City of Stamford
Zoning Board

STAFF REPORT

TO: CITY OF STAMFORD ZONING BOARD
FROM: VINEETA MATHUR, PRINCIPAL PLANNER
SUBJECT: **ZB #224-18 Zoning Map Change**
APPLICANTS: **Continental Family Holdings LLC (Owner) by Michael J. Cacace**
DATE: November 24, 2025 (**Revised December 15, 2025**)

**Map 1.
Proposed
Zoning Map
Change**

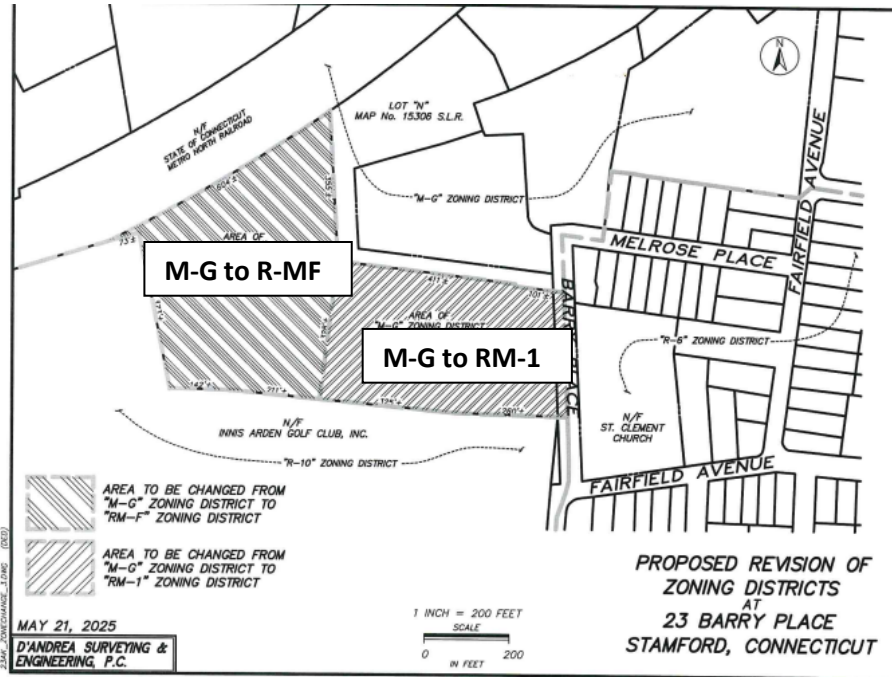
The applicant has proposed a change from M-G to the RM-1 district for the front portion of the site (4.18 acre) and M-G to R-MF for the rear portion (5.13 acre) of the site as shown on Map 1. A comparison of the existing and proposed zoning standards is given in Table 1 below.

As per Section 5.FF.1, Purpose, the R-MF zoning district is set aside for areas which may be developed for *high* middle-density housing in low rise buildings. As further stated in the purpose section, the district intends for new development to be harmonious and compatible with existing buildings. The proposed rezoning of the R-MF portion will allow up to 205 units on the rear portion of the lot. Staff believes that the proposed density is inconsistent with the permitted density in the surrounding area as shown on the chart above. The surrounding zoning districts of R-6, R- 7 ½ and R-10 allow significantly lower density and scale compared to the R-MF zoning district as noted in Table 2. For example, while the requested R-MF zoning district allows 40 units an acre (with BMR bonus), the R-6 district density allows roughly 14 units per acre when developed as two family units on subdivided lots. Actual densities under R-6 will likely be lower to allow for roadways. While the R-MF zoning district allows buildings which are 4 stories/40 feet, the R-6, R 7 ½ and R-10 districts allow 2 ½ story/30 foot tall, detached buildings.

Further, the portion of the parcel proposed for the R-MF district does not have direct frontage on Barry Place but will be accessed through the RM-1 portion of the site. This creates a split lot condition negating the front setback requirement for the R-MF portion of the site and the rear setback for the RM-1 portion.

Staff recommends that the applicant modify their rezoning proposal to better suit the location. Staff believes that other medium density Zoning Districts such as R-5 may be preferable alternatives to the proposed RM-F zoning district. The R-5 zoning district allows buildings up to 3 stories and 30 ft and would allow a density of 22 units an acre (with BMR bonus) resulting in approximately 200 units for a 9.13 acre site. A lower density district such as R-5 would also allow for creation of meaningful at-grade open space.
